October 25, 2021

Kirsten Uchitel, Associate Planner
 SANDAG
 401 B Street, Suite 800
 San Diego, CA 92101
RegionalPlanEIR@sandag.org

Re: *Comments on Draft EIR for SANDAG's Draft 2021 Regional Plan*

Figure 1 The 2030 Climate Stabilization Target Compared to State Mandates

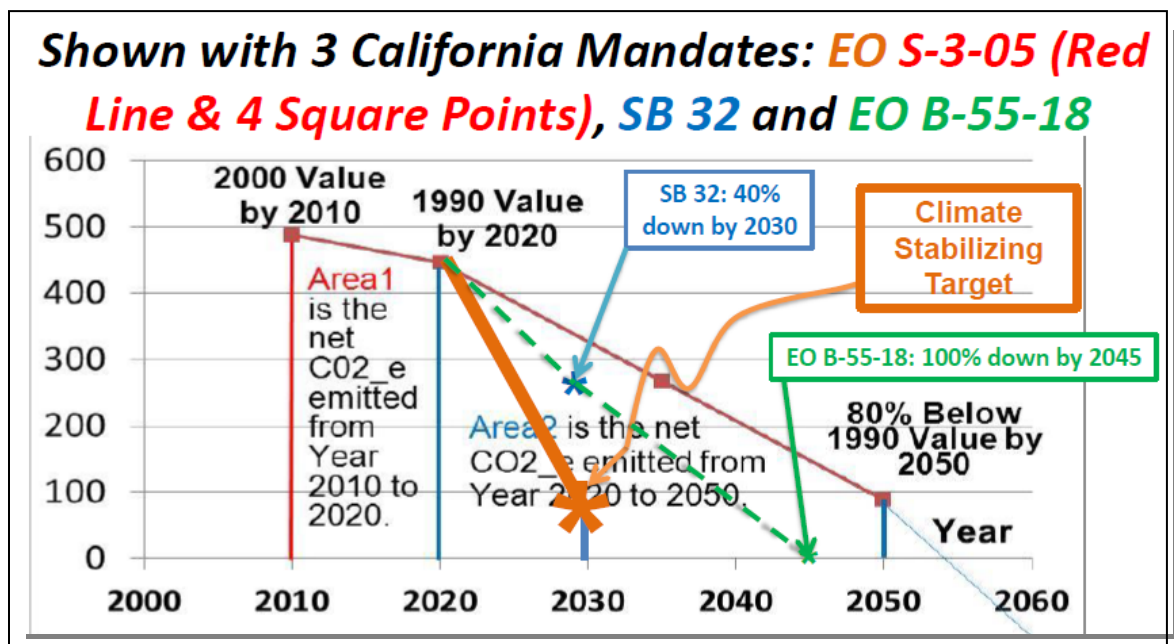
The derivation of the 2030 climate-stabilizing requirement (target) is shown on Page 6 of Reference 1. Reference 2 is used to present Reference 1. The derivation of the 2030 climate-stabilizing requirement (target) is shown on Slides 11 and 12 of Reference 2. That result is shown here in Figure 1.

The *Requirement* is to ensure that our transportation system supports the climate-stabilization requirement of 2030, as shown in Figure 1 of this letter. Reference 1 shows how this can be done, for LDVs. Most of the fleet-efficiency requirements are shown in Table 1 of this letter. (All of the needed fleet-efficiency requirements are described in Reference 1.) Table 1 also shows the driving reduction that is computed in Reference 1. It is a 32% reduction in per-capita VMT, with respect to year 2005. It's expressed using the SB 375 conventions for expressing driving reductions. Even though SB 375 states that it is about a *GHG* reduction, it is really about a *VMT* reduction, because SB 375 clearly states that the Metropolitan Planning Organizations (MPOs, like SANDAG) can take no credit for GHG reductions accomplished by the state. The state has the fleet-efficiency responsibility. The Metropolitan Planning Organizations (MPOs, like SANDAG) have the responsibility to reduce driving. Therefore, the SB 375 reductions in LDV GHG must be produced by SANDAG measures to reduce LDV VMT. In other words, SANDAG's responsibility is to reduce driving.

Figure 5 **The DEIR’s Erroneous Claim of
“Three Primary Challenges”, for our Region**

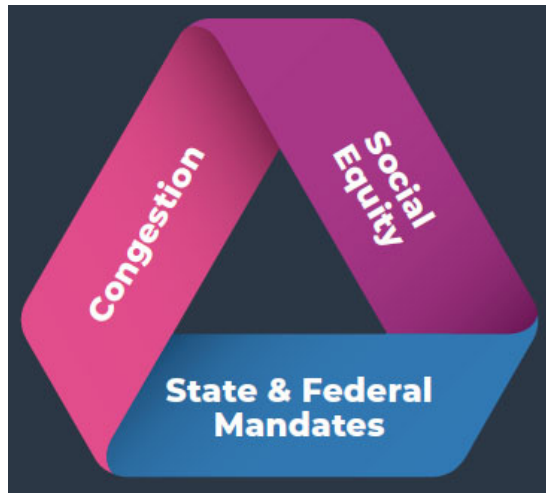
Figure 5 is from Section 1 of the EIR of the RTP. It is said to show our “three primary challenges”

Climate destabilization, as described in Reference 1, will end most life forms and almost certainly our own species. This environmental impact must be fully explained in a legal EIR. The DEIR has no such discussion or explanation.
